# Service Bulletin

Bulletin 2006-21-ABDE

## SUBJECT: SMT Service Interface Board Kits

**Figure 1:** The new H55 service board kit (826-2264) ships with harnesses, which attach the board to the spark module and the sound device.

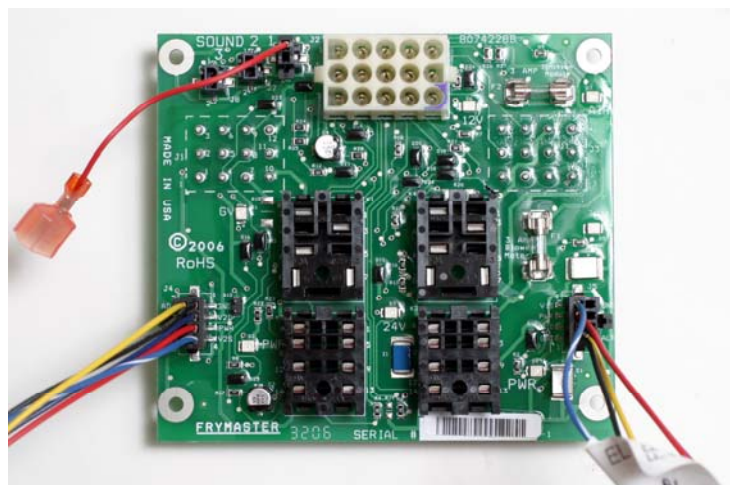
In October, Frymaster and Dean began shipping Surface Mount Technology (SMT) interface boards for selected models in service orders. The first service boards to ship are for the H50/55-series fryer. Instructions are available online: 819-6237; the kit number is 826-2264 (\$152 list). Other service boards will be converted to surface mount in the coming months. Surface mount boards and computers went into production fryers in August 2006. See Service Bulletin 2006-19.

In all cases, the old board's part number will roll to a kit, which will include harnesses for installation of the new board. Harnesses are required to connect the sound device on all boards and spark modules on gas boards. Gas boards will include instructions with color-coded wiring placement guides. Electric boards will include an adapter for the sound device. The new boards are distinguished from the old by the microamp plugs in place of spade terminals. The red LED's have also been replaced by smaller green LED's, embedded in small white cubes.
